SACRAMENTO MUNICIPAL UTILITY DISTRICT □ 6201 S Street, Box 15830, Sacramento, California 95813; (916) 452-3211

August 3, 1982

DOCKET 50-312
RANCHO SECO NUCLEAR GENERATING STATION UNIT NO. 1
AUXILIARY FEEDWATER HEADER REPAIR--ADDITIONAL INFORMATION

CROSS SECTION OF INTERNAL HEADER

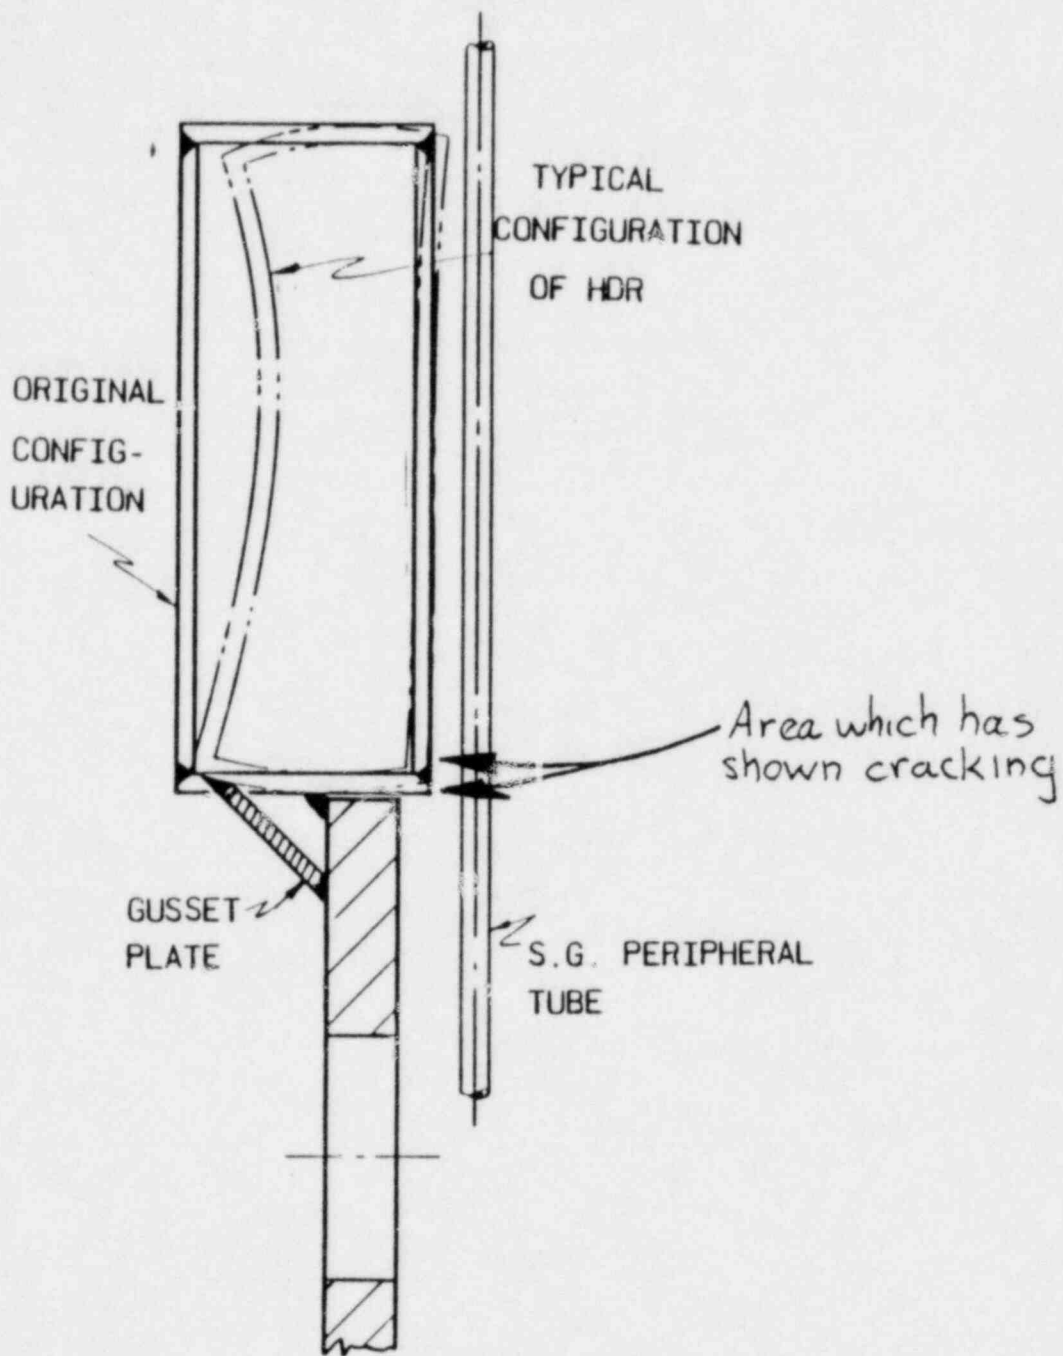
Supply a drawing or drawings which show the limits of each inspection performed. Identify the criteria used to evaluate the soundness of the Header and discuss, where applicable, the ability of the remote visual inspections to detect flaws with respect to the acceptance criteria.

During the course of an inspection, a crack was noted in the lower inside weld of the Internal Header in the "A" Steam Generator. The crack is approximately 20 inches long and is centered at one of the new Auxiliary Feedwater Penetrations. The crack runs along the lower inside weld which joins the inner plate to the bottom of the Internal Header.

Additional inspections have been performed through all of the new Steam Generator Auxiliary Feedwater Penetrations in both Steam Generators. These inspections have specifically looked for cracking in the upper and lower inside welds in the Internal Header. One additional crack was found. This crack was in the lower inside weld in the "B" Steam Generator and was found to extend for approximately 15 inches. The consequences of this imperfection are bounded by the analysis done on the 20-inch crack in the "A" Steam Generator.

The inspections which would have revealed cracking in the Internal Header welds are documented on the attached drawings. In addition, the specific Penetrations which have shown cracking are delineated. An additional sketch shows the weld area which has shown cracking.

Babcock and Wilcox has evaluated this flaw and has found it to be acceptable based on calculations done previously. In addition, B&W will perform an analysis of this flawed Header using a finite element analysis model to assure that the Header will be capable of withstanding any anticipated loads. This analysis will assume the highest anticipated loads would result from a steam line break.
